### Office Action Summary

10/590,139

## DETAILED ACTION

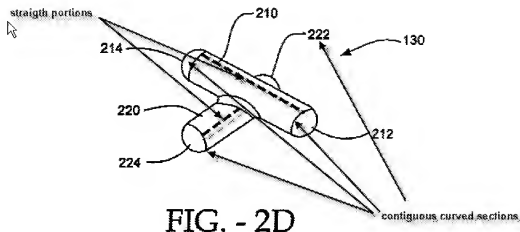
Zucherman et al teaches an intervertebral disc prosthesis comprising a first end plate 110 and a second end plate 120. (Note that the interpretation of the first and second plates can be reversed.) Note bone engagement features 114, 124.

The prosthesis further comprising a nucleus 130 which articulates between said first and second plates as shown in Figure 2D.

Said nucleus having an articular surface comprising a flat section between the contiguous first and second curves sections (either of the upper or lower).

Regarding claim 32, either of the beams 210, 220 are interpreted as "partial cylinders" at least where they connect together. Said partial cylinders, when placed between the plates, slope relative to exterior surface thereof and are interpreted as "sloping partial cylinders".

Regarding claims 33 and 39, the beams 210, 220 are thicker where they join. Therefore, one can select an anterior portion which is thicker than a selected posterior portion. As shown in at least figure 1B, the lordotic angle is greater than zero.

Regarding claim 41, either of the beams 210, 220 are interpreted as "partial cylinders" at least where they connect together. Said partial cylinders, when placed between the plates, slope relative to exterior surface thereof and are interpreted as "sloping partial cylinders". Said cylinders inherently have an engagement feature. Said partial cylinder has a "straight section". Either of the plates 110, 120 have a "second articular surface". At least figure 1B shows the first and second bone engaging surfaces in a "preferred orientation".

Claim 45, see first and second curved sections 212, 214 or 222, 224. The radius of these sections can be a different radius chosen on the partial cylinder away from the section radii.

Claim 43, see first and second curved sections 212, 214 or 222, 224.

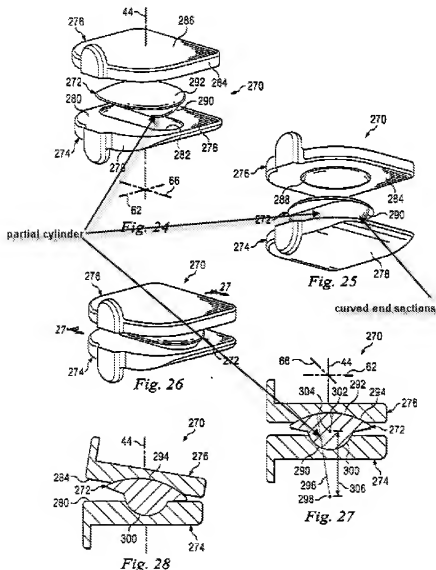
Marik et al teaches an intervertebral disc prosthesis comprising

a first end plate 274 and a second end plate 276 which can comprise bone engagement features such as a flange (stop). The prosthesis further comprising a nucleus 272 which articulates between said first and second plates which urges the

plates into a relative anterior/posterior orientation that provides a preferred lordotic angle including 0 (see paragraph 006 teaches surfaces 278 and 280 may be angled).

Regarding the articulating structure/nucleus has a "sloping partial cylinder" or "straight section sloping", it is the examiner's position that this fails to define over Marik et al. Marik et al teaches that the exterior surfaces 278 and 280 of the nucleus can be angled (par. 0066) as shown in figure 25.

It is the examiner's interpretation that the nucleus can be described as being sloping because it slopes relative to at least surface 278.

Regarding claims 33, 39, 54, 60 a cross section at the posterior can be taken closer to the posterior end when compared to a cross section at the anterior end taken further from anterior end; the chosen anterior portion would have a greater thickness than the chosen posterior portion. The device is interpreted as having a preferred lordotic angle greater than zero.

Regarding at least claims 43, Marik et al teaches a partial cylinder (as shown) which comprises a flattened portion in one cross section flanked by first and second curved ends which inherently have a different radii.

Claim 52, see surface 284 which comprises a concave recess and a flat portion. Also see paragraph 0066 which states, "the interior surface may include a concave recess 288" which is interpreted as being optional.

Claim 58, fourth surface 288 is interpreted as being substantially flat.
